Form 3160-5
(March 2012)UNITED STATES
DEPARTMENT OF THE INTERIOR
BUREAU OF LAND MANAGEMENTFORM APPROVED
OMB No. 1004-0137
Expires: October 31, 2014**SUNDRY NOTICES AND REPORTS ON WELLS**
Do not use this form for proposals to drill or to re-enter an abandoned well. Use Form 3160-3 (APD) for such proposals.

Round Tank Queen Unit #4

ROUND TANK QUEEN UNIT #4
(BRUNNER FED. #1)
1980' FSL & 660' FEL ("I")
SEC 25-T15S-R28E
CHAVES COUNTY, NM
API No.: 30-005-00396
SPUD DATE: 9/30/1962
LEASE No.: NM-02858-A

Permanent Abandonment of Federal Wells Conditions of Approval

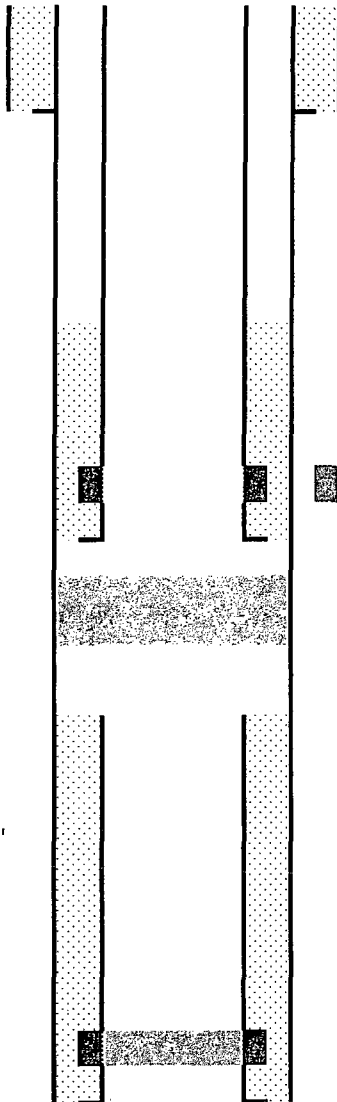
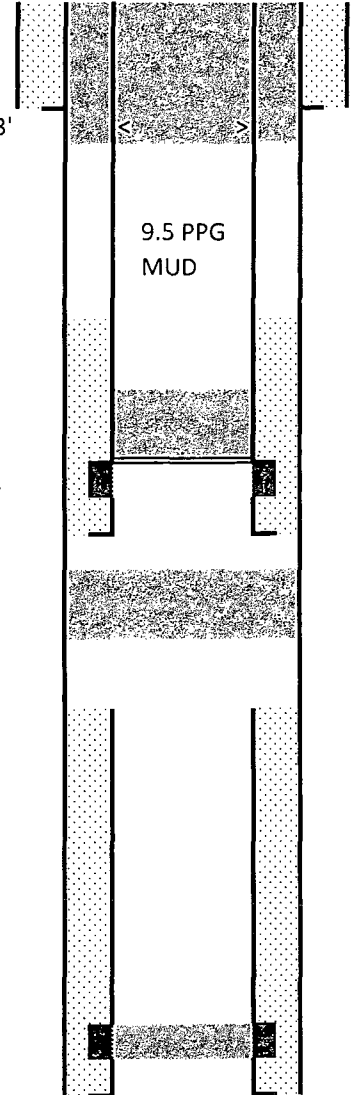
1. Set CIBP @ 1400', spot +100' Class "C" cement from 1400'-1300', 25 sx. POH, SD, WOC, TIH and tag plug, circulate hole w/ 9.5 ppg mud.
2. Perf 4-1/2" casing @ 363', w/ 4 shots, 90 deg phasing. Establish circulation, pump 80 sx Class "C" cement, circulate annulus with cement and leave 4-1/2" casing full of cement.
3. Cut off wellhead and install dry hole marker. **BGL**
4. Clean location, cut off anchors, remove caliche, rip location and reseed.
5. Notify BLM for Final Inspection.

**SEE ATTACHED FOR
CONDITIONS OF APPROVAL****APPROVED FOR 3 MONTH PERIOD
ENDING APR 17 2014**

5. **Cement Requirement:** Sufficient cement shall be used to bring any required plug to the specified depth and length. Any given cement volumes on the proposed plugging procedure are merely estimates and not final. Unless specific approval is received, no plug except the surface plug shall be less than 25 sacks of cement. In lieu of a cement plug in cased hole, a bridge plug set within 50 feet to 100 feet above the perforations shall be capped with 50 feet of cement. If a bailer is used to cap this plug, 35 feet of cement shall be sufficient.
